**SUBJECT:** Statutory public meeting and recommendation report for an official plan amendment, zoning by-law amendment and plan of subdivision for 2294 & 2300 Queensway Drive

**TO:** Community Planning, Regulation & Mobility Cttee.

Report Number: PL-17-20

File Numbers: 505-05/19, 520-10/19, & 510-02/19 (24T-19002/B)

**Figure 2 – Proposed Site Layout**

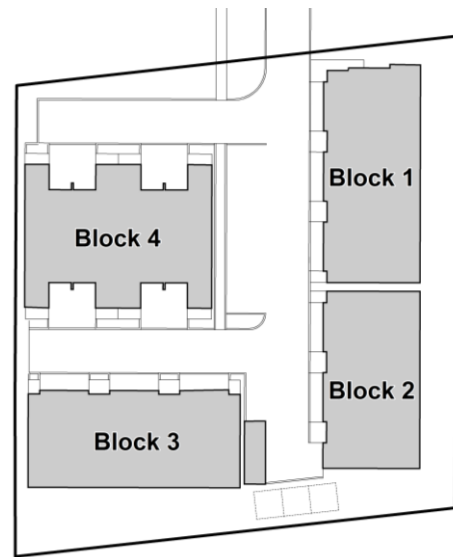
The submitted materials for the subject applications show a part of Block 1 (containing one unit) and site-critical infrastructure (including manholes and catchbasins) within the City and MTO's required 7.5 m setback from Queensway Drive.

However, Transportation staff comment that the two northerly visitor parking spaces (V1 and V2) proposed are situated too close to proposed access. As a result, the two northerly spaces are recommended to be eliminated.

Lastly, Transportation staff also comment that the proposed driveways of the back-to-back townhouses are deficient in length. 6.3 m is proposed, whereas the Zoning By-law requires a minimum driveway length of 6.7 m for POTLs. The required 6.7 m length ensures that longer vehicles (such as pickup trucks) can park without obstructing the private laneway.

Block 1 is sited within 7.5 m of the north property line. This does not conform to the policies of the Official Plan to protect for the deemed width of Queensway Drive, and is not supported by City staff or the MTO.

Furthermore, Fire Services staff comment that the siting of Block 1 from the private laneway does not comply with the Ontario Building Code. Principal entrances are required to be setback at least 3 m from a fire access route. The proposed entrances of Block 1 are located 2.6 m from the fire access route.

The proposed garbage room does not comply with the Zoning By-law’s setback requirements from the south property line and from Block 3. The garbage room is proposed to be located 60 cm from Unit 12 of Block 3 (directly under a second storey window) and 6 m from the south property line. Staff do not support the proximity of this building to Block 3 as it will result in negative odour and noise impacts on Unit 12, and the gap between this building and Block 3 creates a space for people, objects, litter, and wildlife to get trapped. This building should be relocated so as to provide landscaping to buffer this building from the proposed townhouses.

**City Transportation** - City Transportation staff comment that the 7.5 m clear zone at the front of the property now includes Units 1 and 2 as well as the common driveway access for Units 22, 23, 24 and 25. This clear zone was intended to be free from site-critical features and must be amended. Units 1 and 2 must be removed from the site plan. Transportation Services has no concerns if the east-west private road to Units 22-25 exists in the clear zone. If the road is widened in the future, this access may be removed, and the driveways for those units would be extended to be accessed from Queensway Drive.

Visitor spots 1 and 2 on the site plan should also be removed as they are too close to the proposed access. Also, driveways on the Block 4 units should be 6.7m in length instead of 6.3 m.

The MTO would consider accepting a revised application that is similar to the May 2019 concept, if the proposal is revised to keep the 7.5 m block free and clear of buildings and site-critical infrastructure, and if the driveways of the Block 4 units are redesigned to project outwards to Queensway Drive, rather than share a common element driveway. The north end unit of Block 1 (as shown on the May 2019 concept plan) should be revised to have a front-facing porch/door entrance, as opposed to the side-facing porch/door entrance.
